TODOROSKI
AIR SCIENCES

INDEPENDENT AIR QUALITY REVIEW WESTCONNEX - M4 EAST

NSW Department of Planning & Environment

10 February 2016

Figure 5-11: Source contributions for the maximum 1-hour NO_2 concentrations

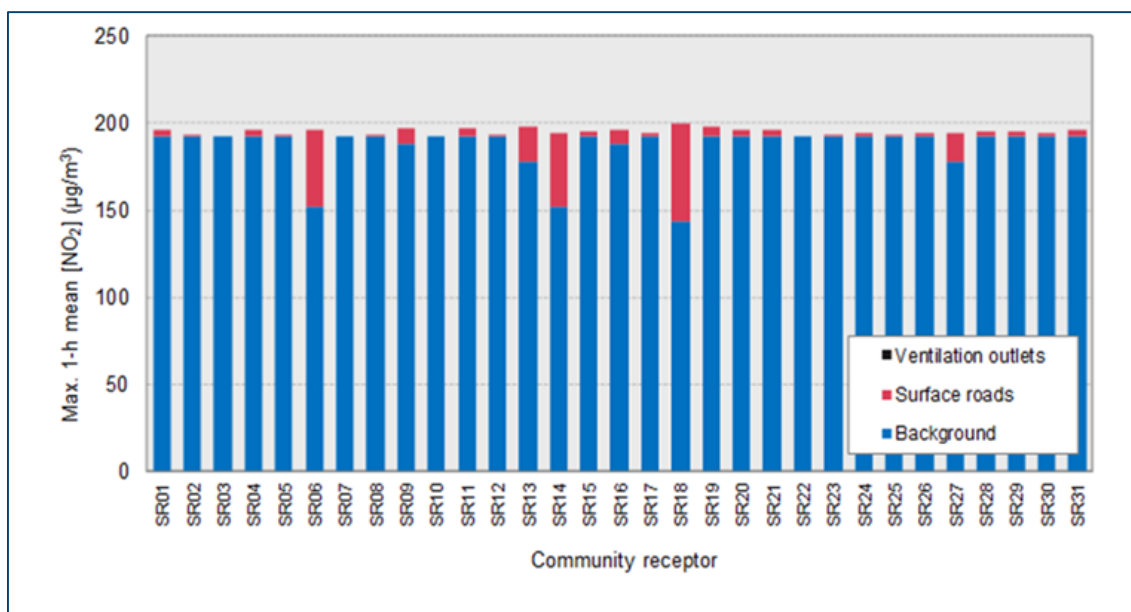
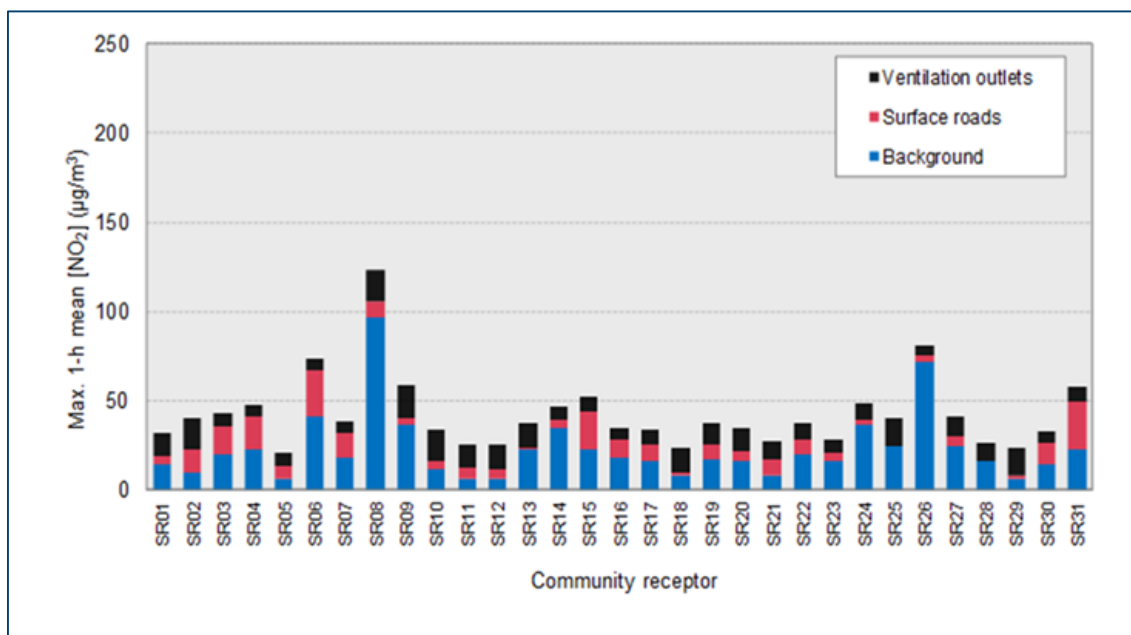
The figures demonstrate that the maximum impacts from the ventilation outlets occur when contributions from the surface roads and background are low and conversely, the maximum predicted concentrations at receptors occur when the contribution from the ventilation outlets are very low. The Proponent proposes further steps to address NSW EPA comments on the assessment of the regulatory worst case scenario.

Following comments from the NSW EPA regarding the assessment of the regulatory worst case scenario, the Proponent presented the maximum predicted total 1-hour NO_2 concentrations from all source contributions and the maximum predicted 1-hour NO_2 concentrations when the maximum NO_x contributions from the ventilation outlet occurs in **Figure 5-11** and **Figure 5-12**, respectively, for the community receptors.
